NORTH CAROLINA DIVISION OF **AIR QUALITY**

Air Permit Review

Applicant (Facility's Name): Teijin Automotive Technologies NC Composites, LLC-

Teijin Automotive Technologies NC Composites, LLC- Salisbury has submitted a permit application (8000176.24B) for a minor modification to its existing Title V permit 09076/T13, pursuant to 15A NCAC 02Q .0515 - Minor Permit Modifications.

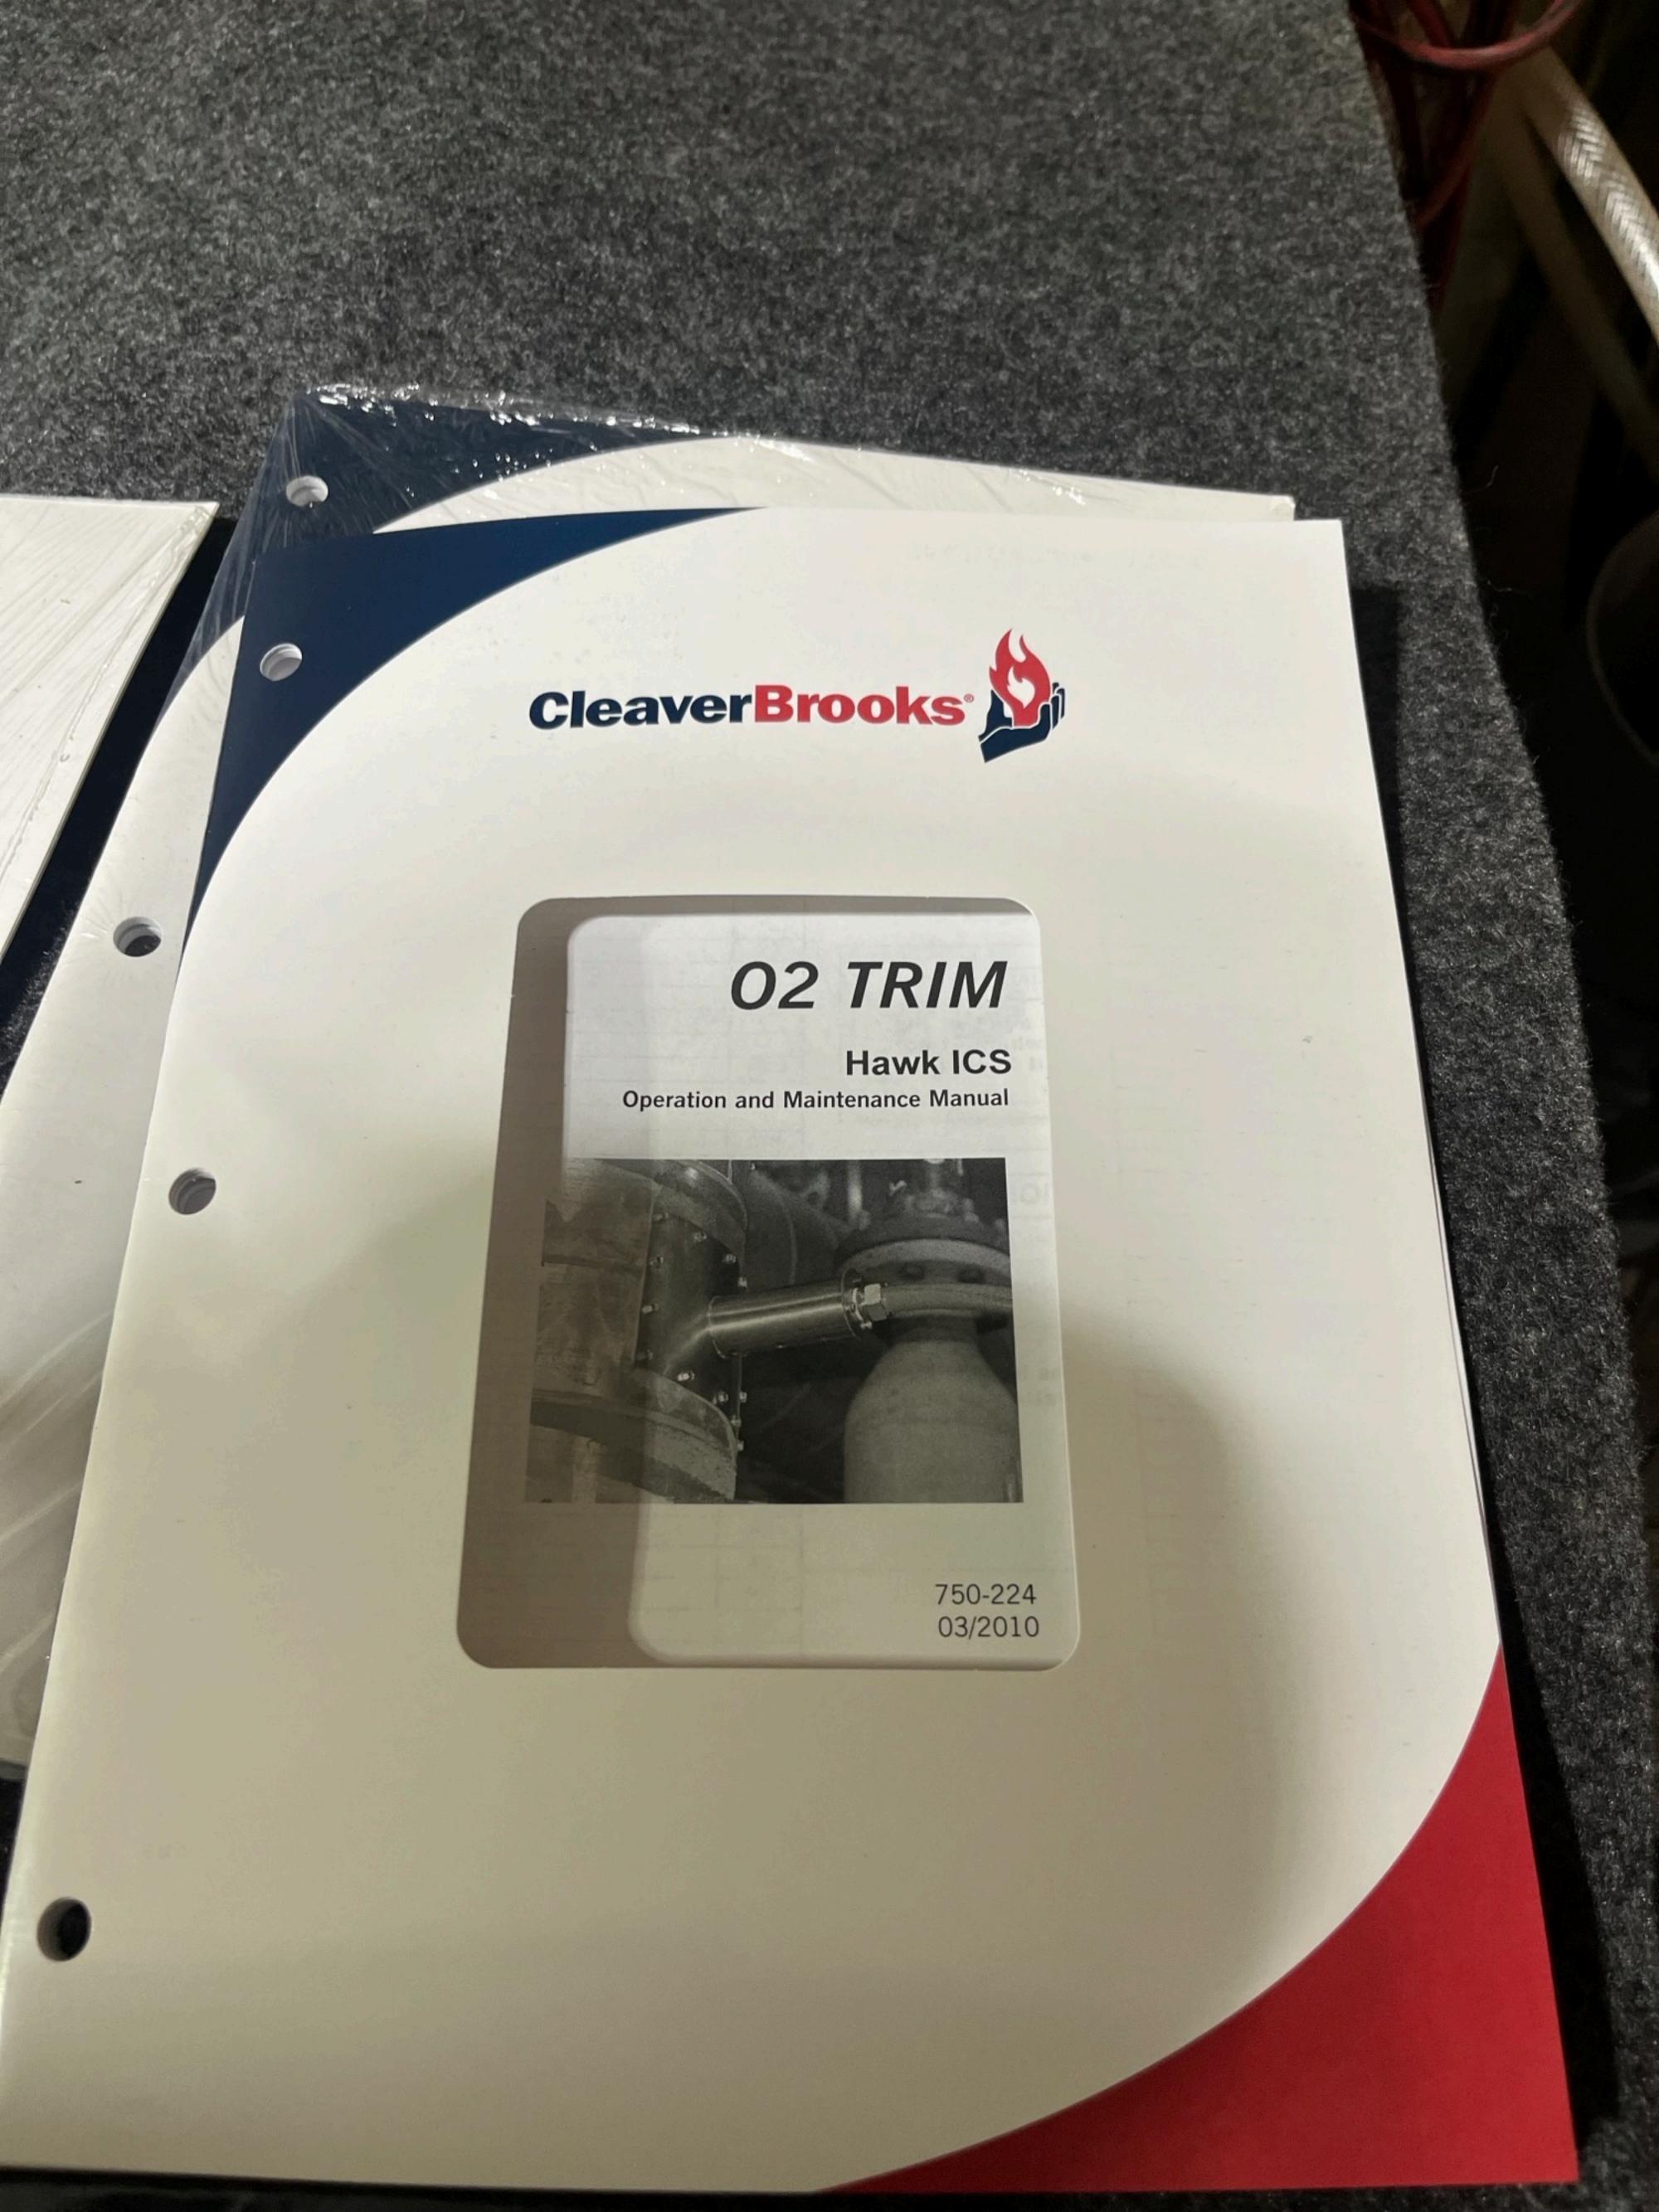
- Does the new boiler (model # CBLE4D700-400-150-ST, 13.39 MM BTU/HR) have oxygen trim? I can't find the boiler manual on CleaverBrooks website.
- Per our phone conversation last week, the facility will remove the old boiler (12.25 MM BTU/HR) first, and then install the new boiler. Please confirm it.
- In the phone call, you said that the letter of Zoning Consistency Determination (ZCD) along with revised Forms A1 and B were mailed last week. We haven't seen them yet. Please verify you mailed them to DAQ Raleigh Central Office or DAQ MRO regional office.

Please find attached the updated boiler-specific emission source information on Form B as requested for the minor modification application 8000176.24B. The new boiler, which includes an oxygen trim, is detailed in the manual. See cover image attached.

The facility will proceed with removing the old boiler and installing the new boiler after the older one is removed. Additionally, I have attached the facility-wide potential emissions rates as filled out on Form D1 for the facility permit renewal application 8000176.24A.
